ATTACHMENT 3

Supplemental Statement of Dr. Seth R. Reice

Creekside Subdivision
January 15, 2003

Figure 1: Station Numbers

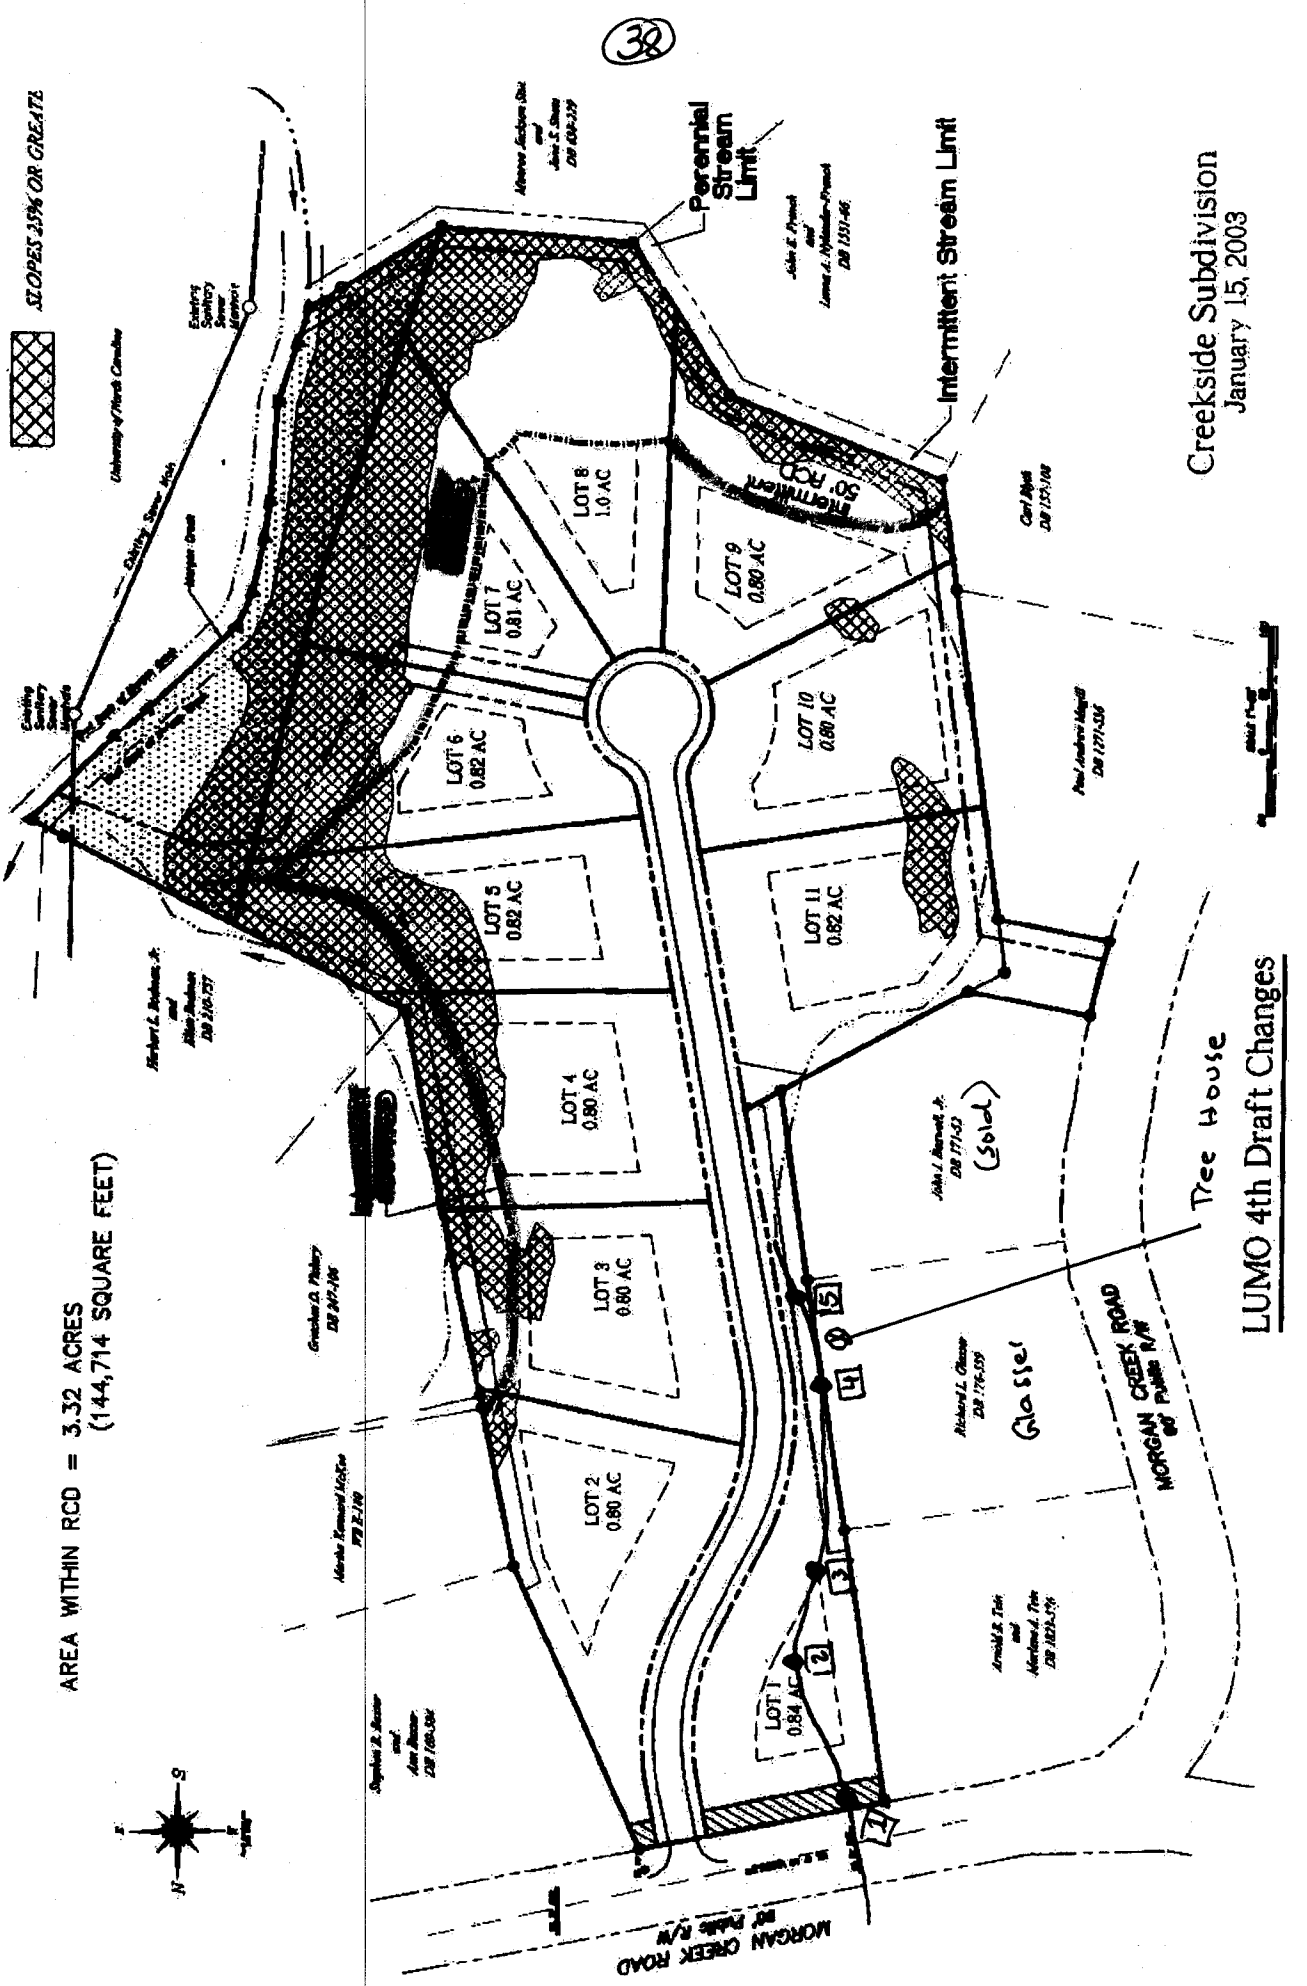
Further, since the presentation I have realized that the plat map included in my report to identify the five "sampling stations" is in error. Several of the locations identified do not correspond to the narrative descriptions of these locations. The narrative descriptions, and the photos included in the report, are accurate. They make it clear that on Feb. 3 I sampled from just below Morgan Creek Road to a point no farther south than the southern end of the Glasser property. (My descriptions of Stations 4 and 5 refer to the Glasser's grey house and the tree house on their property, as well as a log bridge and a large stack of wooden poles that are directly behind their property.) I sampled no farther downstream than that because on that day, there was no water visible below that point.

Attached are the narrative descriptions and a revised map. The revised locations are approximate, but they accurately show that I sampled no farther downstream than the southern end of the Glasser lot. What this suggests is that the relatively diverse microbenthic community that I have described exists farther upstream than the earlier map indicated.
